City of FRESNO

CITY OF FRESNO – ADDENDUM NO. 1

RIVER WEST FRESNO EATON TRAIL EXTENSION, PHASE 1

BID FILE NUMBER: 12700455

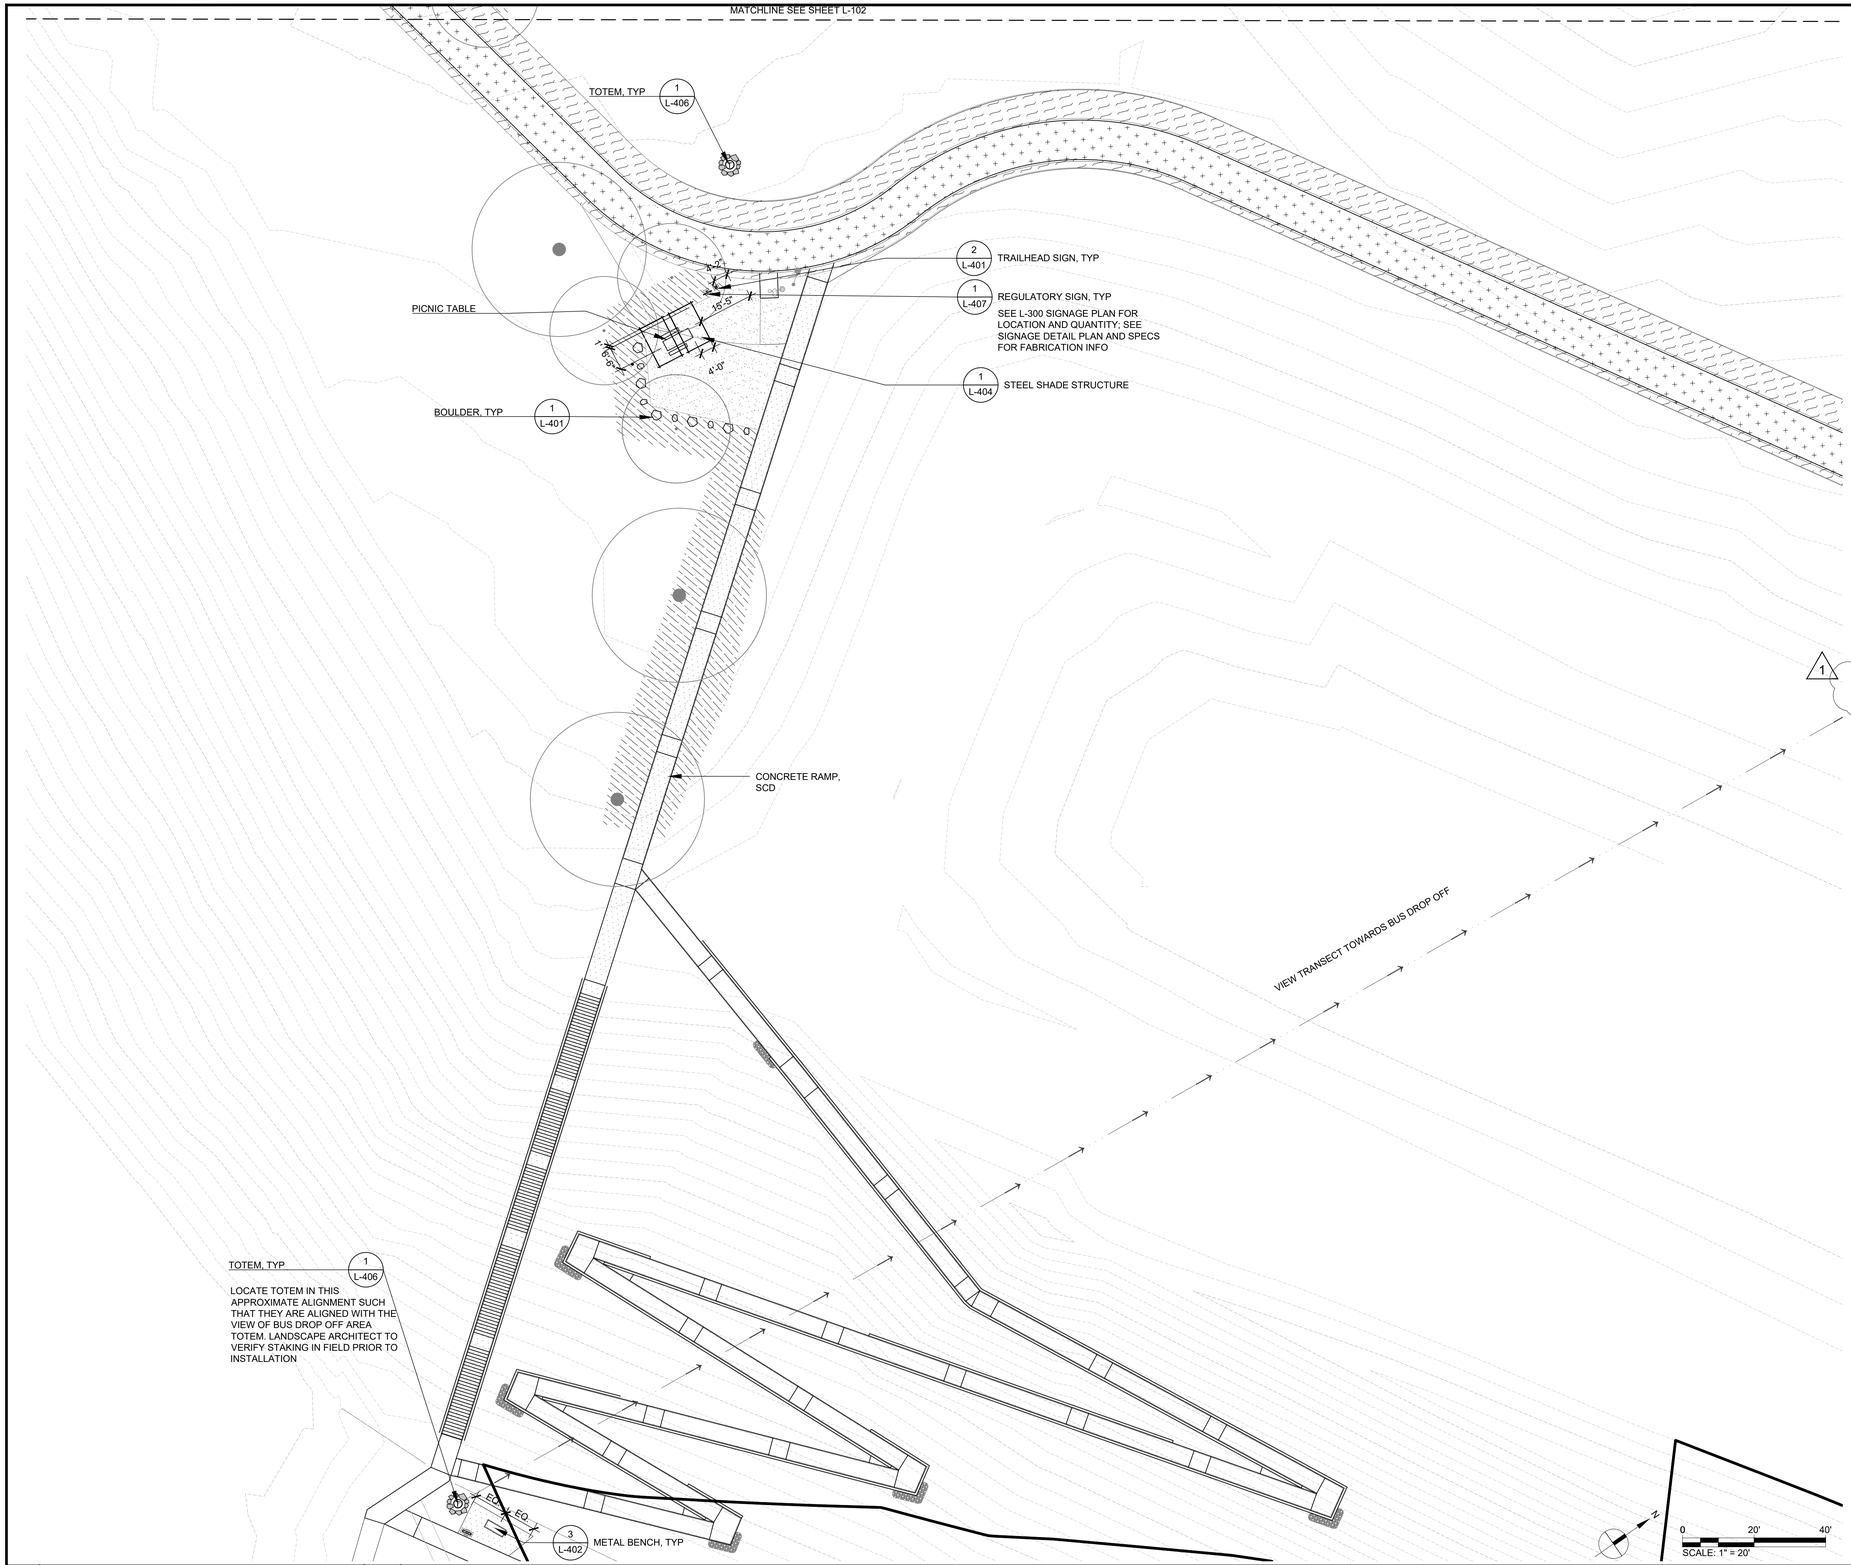
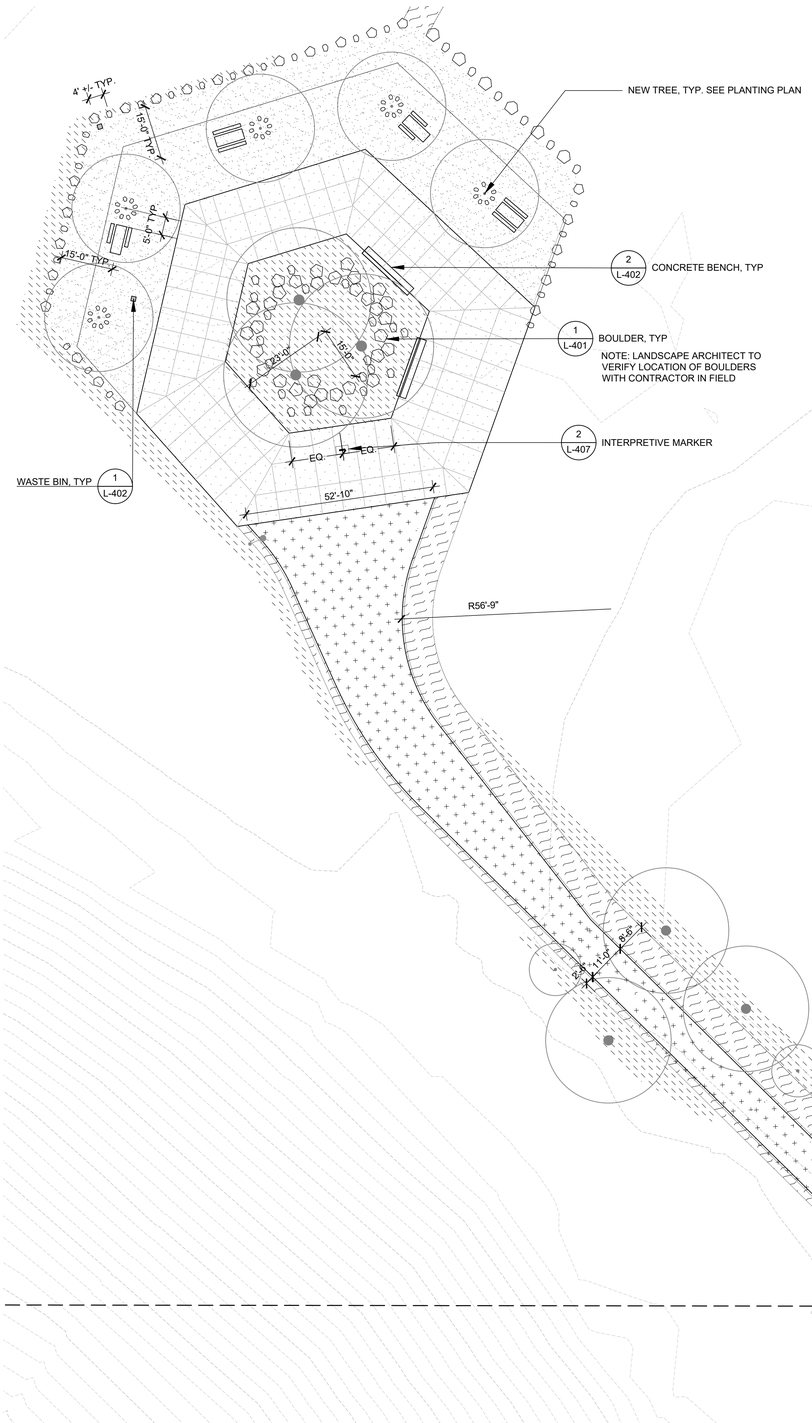
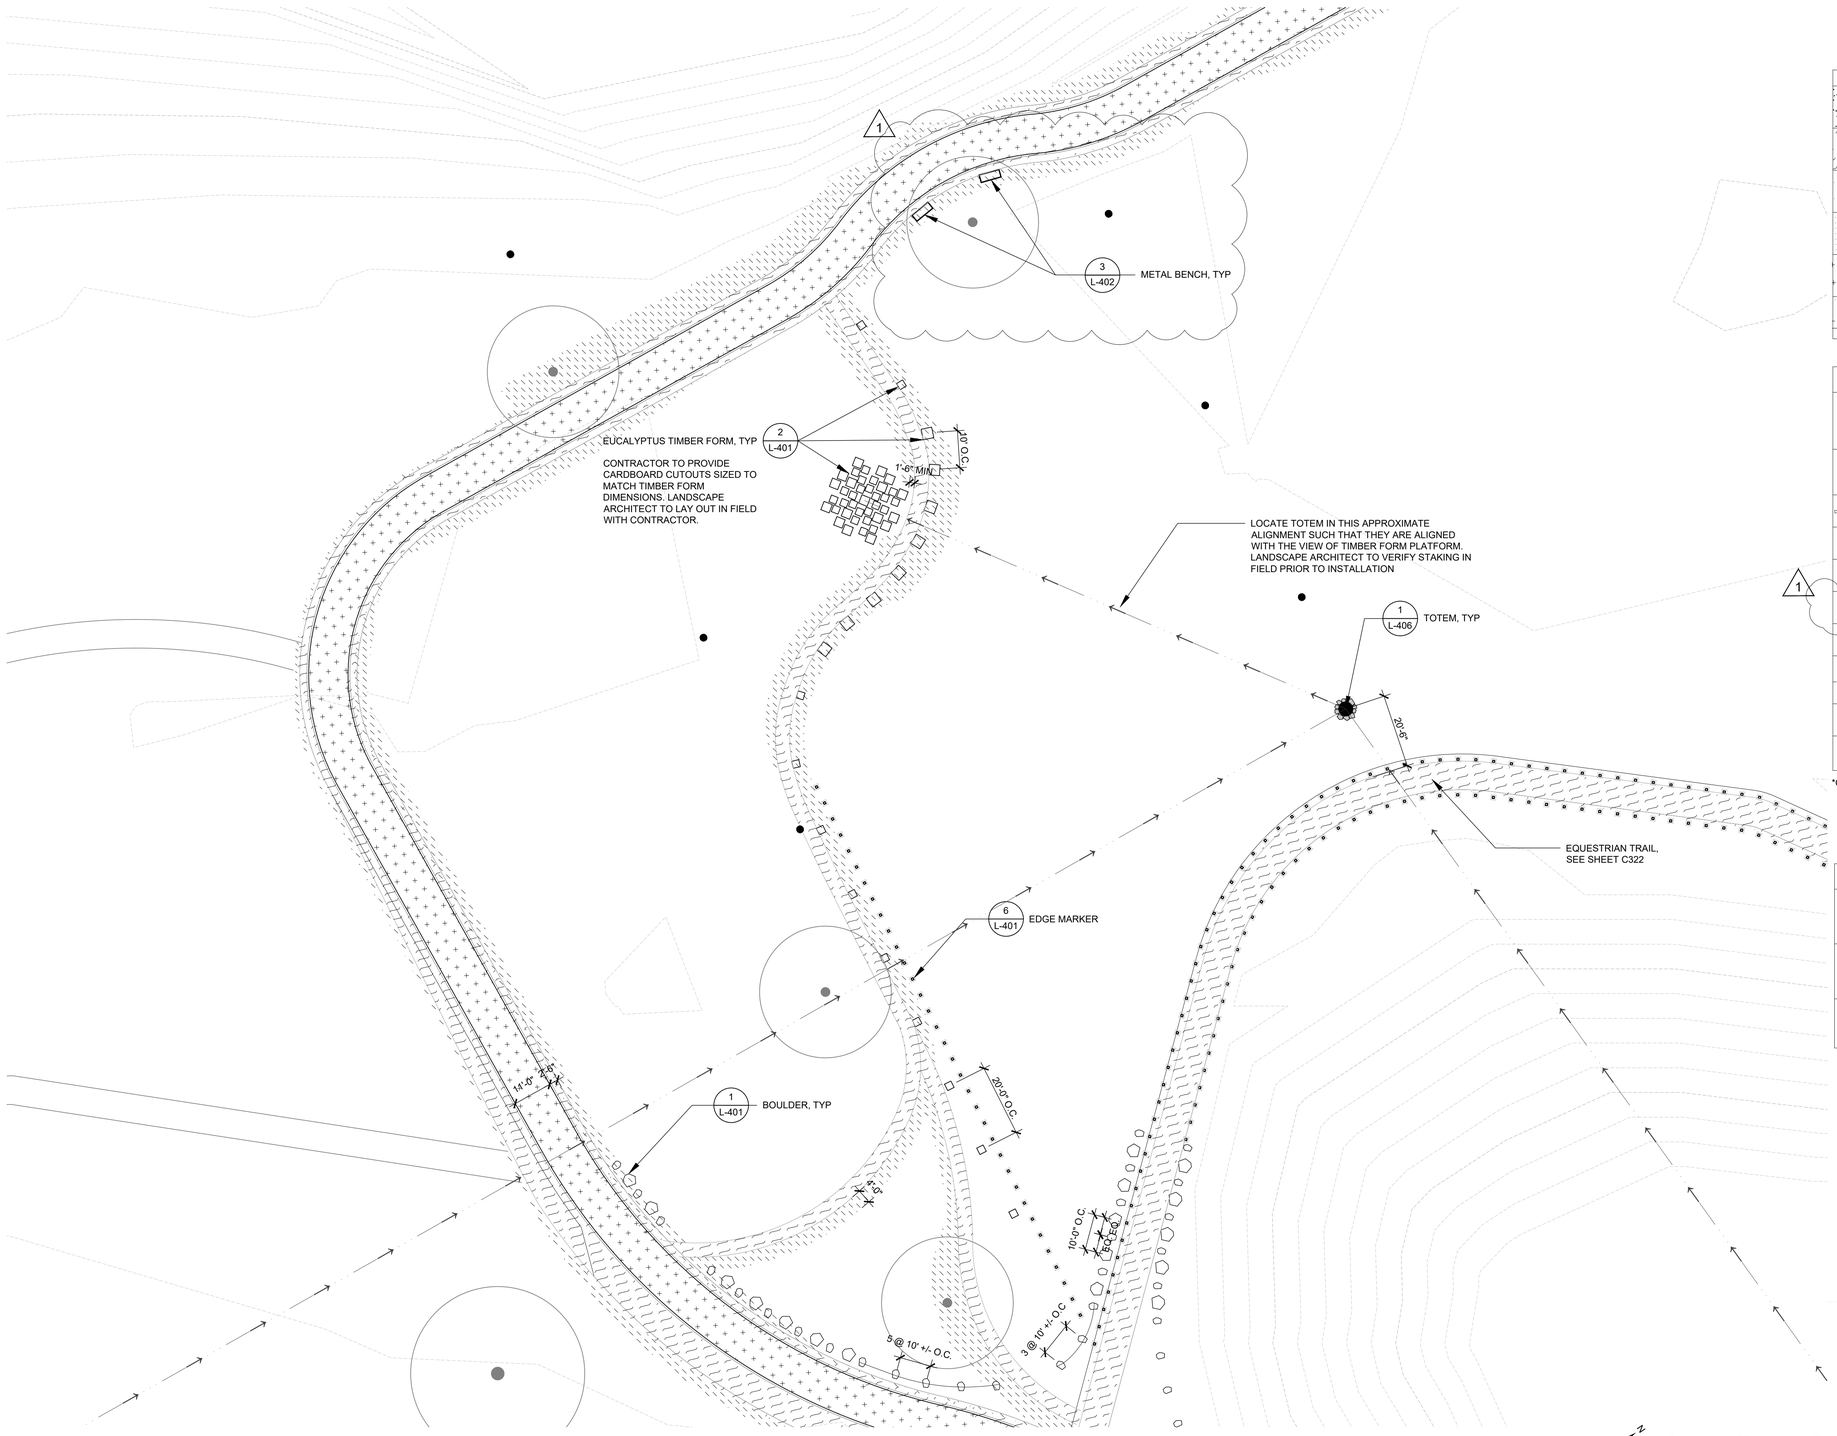
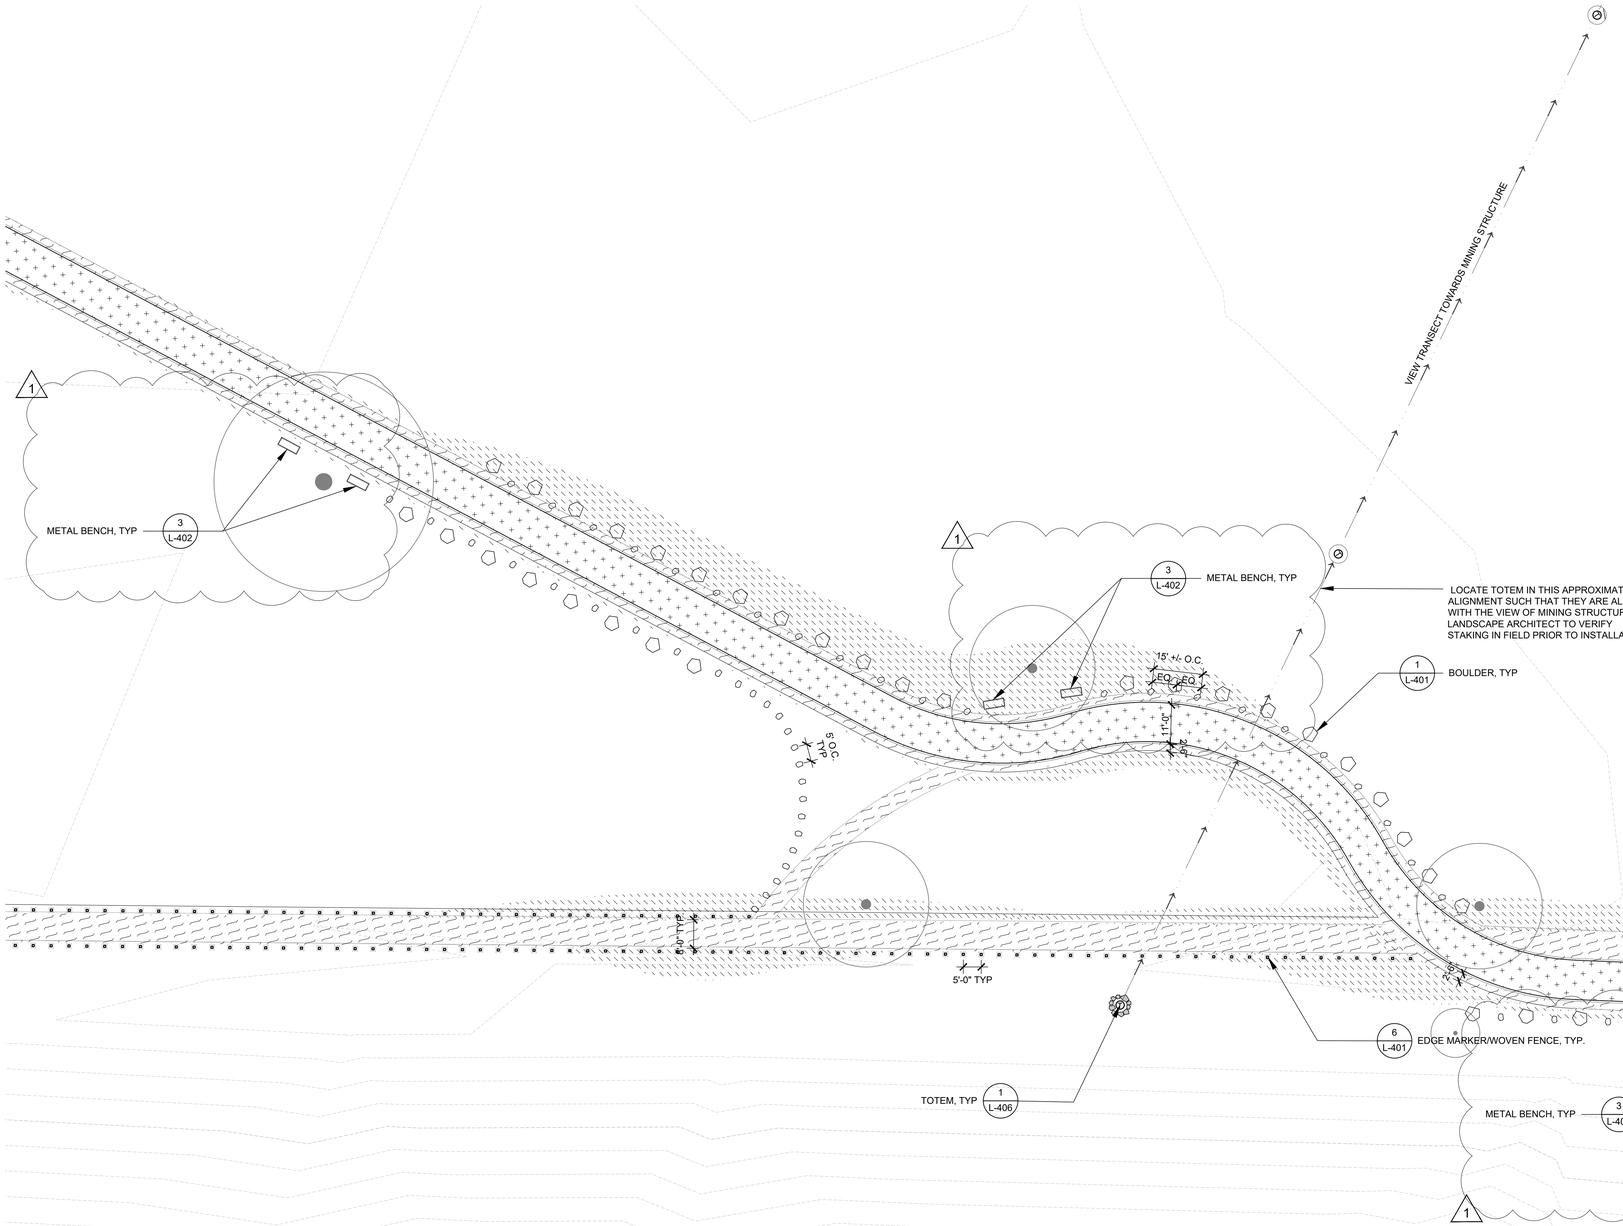
On Material Plan L-101 through L-110 shows quantity for Metal Bench is 15 EA, but on legend and specifications shows quantity for Metal Bench is 47 EA. Please confirm quantity for Metal Bench.

8. Modification to Material Plans on Plan Sheet 15-E-14656 to 15-E-14666:

- Remove and Replace Sheets No. 15-E-14656 to 15-E-14666, Sheets 75 to 85 of 133, entirely with Addendum No. 1 Drawing Sheets No. 15-E-14656

(Addendum No. 1) to 15-E-14666 (Addendum No. 1), (clouded and marked ADDENDUM NO. 1) which modifies the number and location of metal benches.

Response:
There is a total of 23 Metal Benches. See updated Addendum No. 1 Drawing Sheet No. 15-E-14656 (Addendum No. 1) to 15-E-14666 (Addendum No. 1), 75 to 85 of 133, with changes clouded and marked ADDENDUM NO. 1, which clarifies the number and location of metal benches. See updated Specifications Division I Bidding and Contract Documents, Bid Proposal page 1.3 (Addendum No.1) and Division VI Technical Specifications page 6.12 (Addendum No.1) Bid Item Description for Bid Item 29 - Site Furnishings.
